# Moolarben Coal Independent Water Quality Study

## Summary

The EPA subsequently received a report from Moolarben authored by Professor Barry Noller entitled *Moolarben Coal Independent Water Quality Study (IWQS)* and dated 10 December 2021. The EPA requested DPE Science, Economics and Insights assist in the review of the IWQS report.

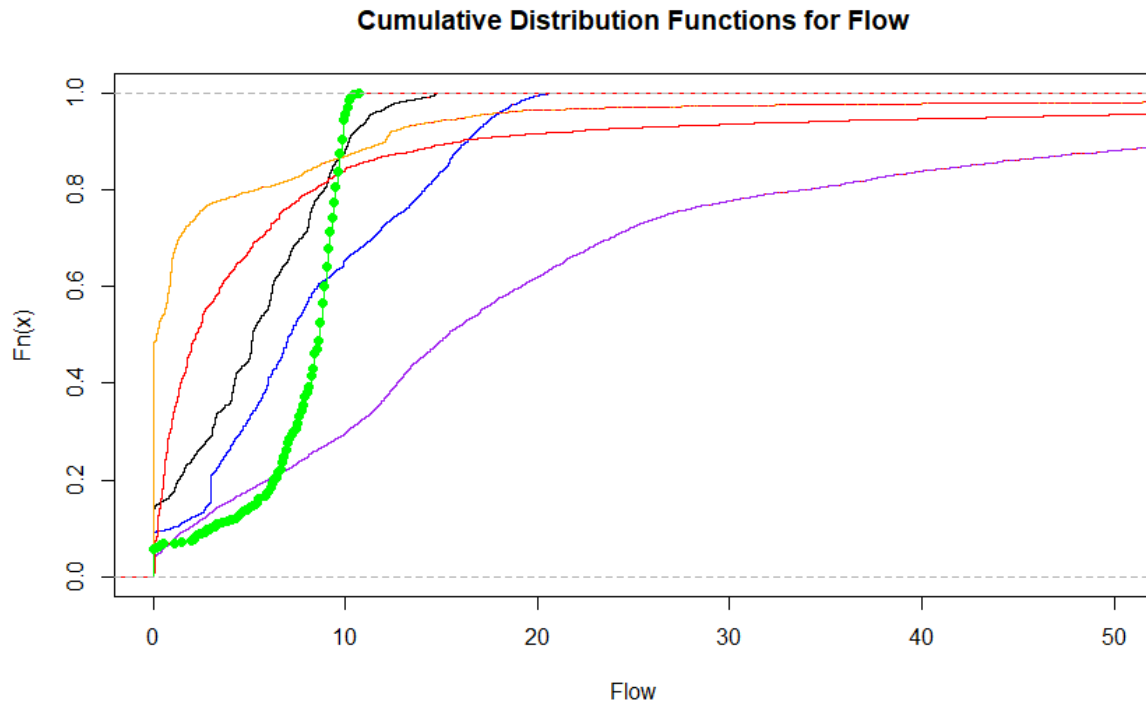
The IWQS appears to have relied on only one sample (taken 24 June 2021<sup>14</sup>) for toxicity testing. If information on the Upper Goulburn River on the date the sample was taken is analysed in detail:

- Rainfall at the BoM Ulan rainfall gauge was 1mm on 24 June 2021
- Flow at SW01 was recorded to be 10.4 ML/day on 24 June 2021
- Discharge from MCO LDP1 was recorded as 7.8 ML/day on 24 June 2021
- Combined Discharge from UCML LDP6 & LDP19 was recorded as 22 ML/day on 24 June 2021
- Flow at SW02 was recorded to be 63.6 ML/day on 24 June 2021.

This leaves a difference in flow between SW01 and SW02 of 53.2 ML/day. After allowing for cumulative mine discharges on this day (29.8 ML/day), this leaves 23 ML/day<sup>15</sup> of flow unaccounted for. The two major streams in the area that join the Goulburn River in between SW01 & SW02 (Ulan Ck and Bora Ck) would collectively have to be discharging twice the amount of water measured at SW01 to explain this difference. This suggests that either significant (unmeasured flows) are coming from tributaries in-between SW01 and SW02, or there are considerable inaccuracies in the flow ratings curves and flow measurements for SW01 & SW02. This issue needs further detailed investigation.

There are significant discrepancies in the flow records at times, including unexplained flow additions in between SW01 (upstream of discharge locations) and SW02 (downstream of discharge locations).

Further flow monitoring in unmonitored streams (i.e., Ulan Ck upstream of UCML discharges; Bora Creek upstream of MCO discharges; Sportsman Hollow Creek) is required to resolve whether there are quality assurance/quality control issues with existing gauges (at SW01 and SW02). The accuracy of discharge flow measurements (at MCO LDP1, and UCML LDP6 & LDP19) also warrant further investigation.

Figure 4. Discrepancies in Conductivity levels measured on the same day in the Upper Goulburn River. Data Sources: Moolarben Coal (M\_SW12 & M\_UCMLSW01) and UCML (SW01).

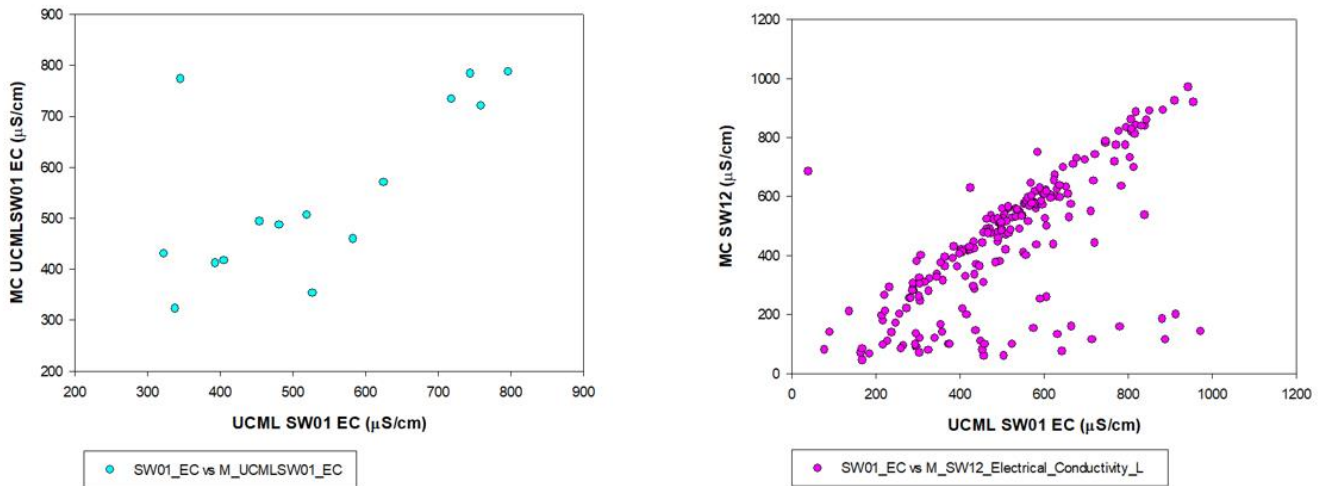
- EC levels in the Upper Goulburn River are affected by drought and by upstream flows during rain events;
- There are discrepancies in measured EC levels at UCML site SW01 and MCO sites UCMLSW01 & SW12 on the same day;

The IWQS did not identify or discuss the discrepancies between Moolarben Coal's and UCML's EC levels measured in the Upper Goulburn River on the same day for sites in close proximity (UCML SW01 and SW12)<sup>26</sup>.

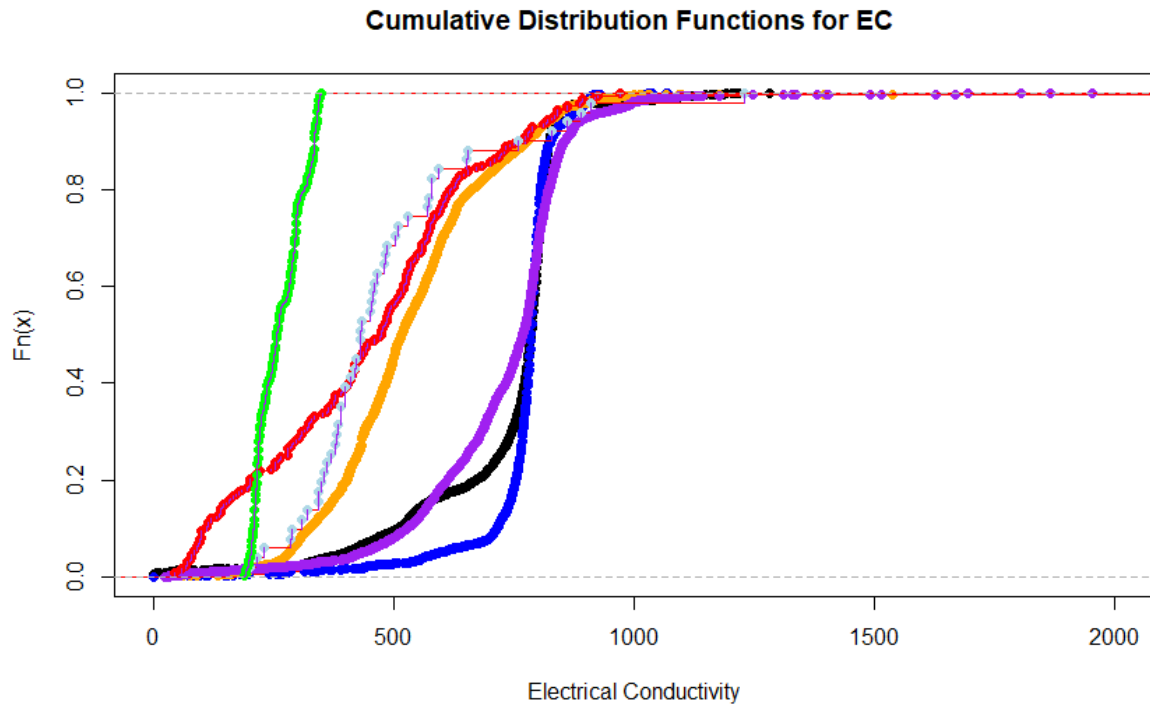
- The IWQS background calculations are primarily based on results for SW12 with MCO UCML SW01<sup>17</sup> results restricted to the 2016/2017 period;
- Over the period 1968-1982 (n=50) the median conductivity recorded for Station 210046 was 432  $\mu\text{S}/\text{cm}$  and the 80<sup>th</sup> percentile was 580  $\mu\text{S}/\text{cm}$ ;

- The long-term median EC level at SW01 is 517  $\mu\text{S}/\text{cm}$  (UCML Annual Reports; maximum 3389  $\mu\text{S}/\text{cm}$ <sup>18</sup>);
- The long-term median EC level (since 18/5/2020) from MCO LDP1 is 258  $\mu\text{S}/\text{cm}$ <sup>19</sup> (maximum 349  $\mu\text{S}/\text{cm}$ );

The dataset used for EC calculations did not include any of the earlier data for GS210046<sup>24</sup>. If the earlier GS210046 data are added to the EC data used to generate an 80<sup>th</sup> percentile EC level in the IWQS, then using the ANZECC approach the result would be an EC level of **616  $\mu\text{S}/\text{cm}$** <sup>25</sup>.

Figure 6. pH levels in the Upper Goulburn River. Data Sources: Moolarben Coal and UCML.

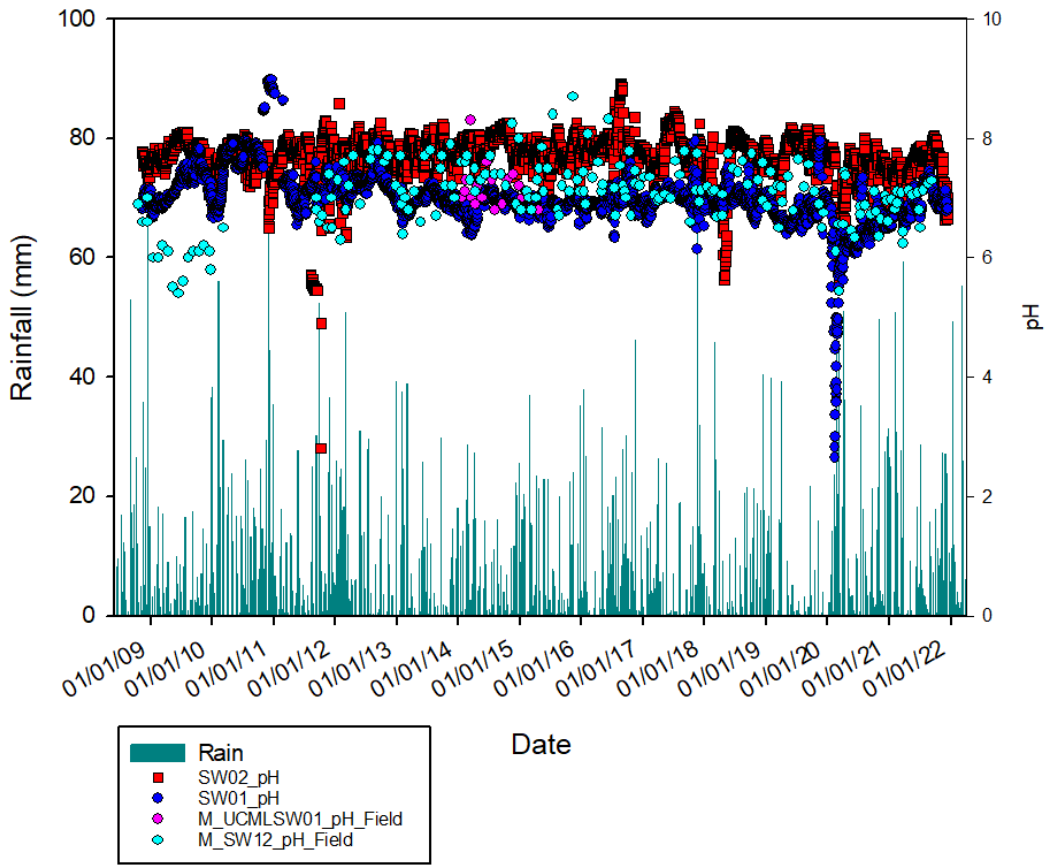
- pH levels in the Upper Goulburn River are also affected by drought and by upstream flows during rain events;
- pH levels recorded at SW12 were often much higher than those recorded at SW01<sup>30</sup>;
- The long-term median pH level at SW01 is 6.96 (UCML Annual Reports; maximum 8.99);
- The long-term median pH level (since 18/5/2020) from MCO LDP1 is 7 (maximum 7.3);
- The long-term median EC level from UCML LDP6 is 7.6 (UCML Annual Reports; maximum 8.76);
- The long-term median EC level from UCML LDP19 is 7.17  $\mu\text{S}/\text{cm}^{31}$  (UCML Annual Reports; maximum 9.09); and
- The long-term median EC level at SW02 is 7.73 (UCML Annual Reports; maximum 8.91).

Figure 7. Concentration exceedance curves for pH in the Upper Goulburn River. MCO LDP1=green; MCO IWQS EC=red; UCML SW01=orange; UCML SW02=purple; UCML LDP6=black; UCML LDP19=blue. Note the

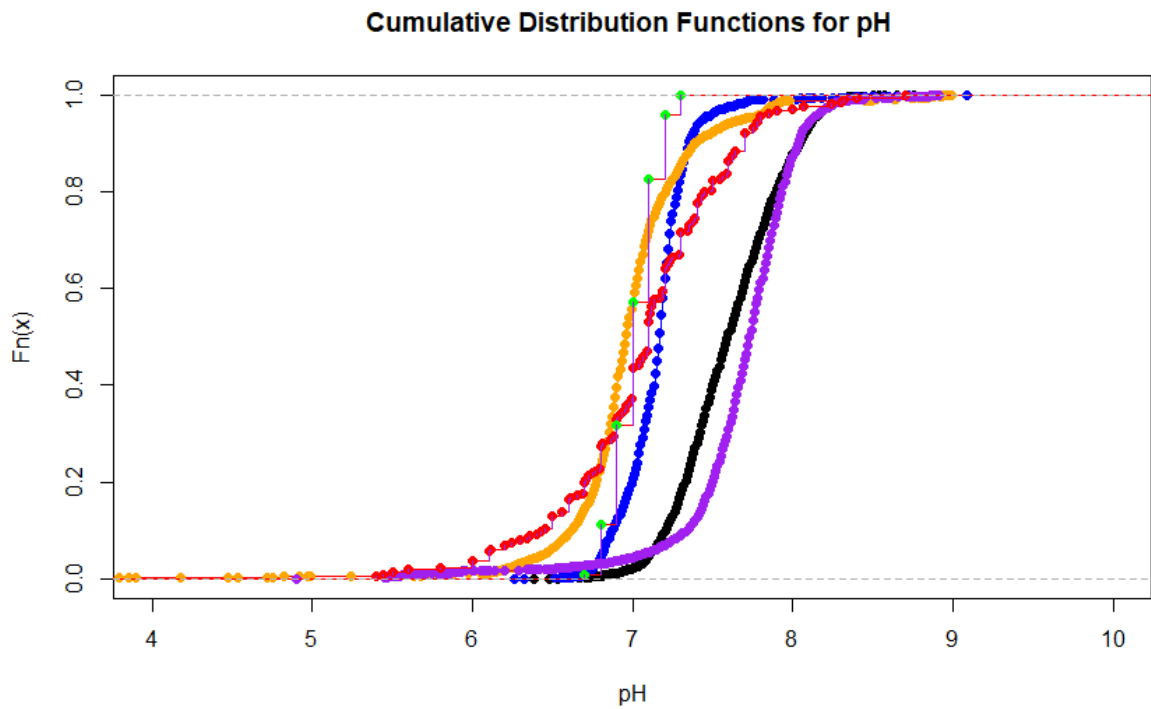
The discharges into the Upper Goulburn River significantly alter the pH of the waters<sup>32</sup> making them much more alkaline than that measured at the upstream SW01 site.
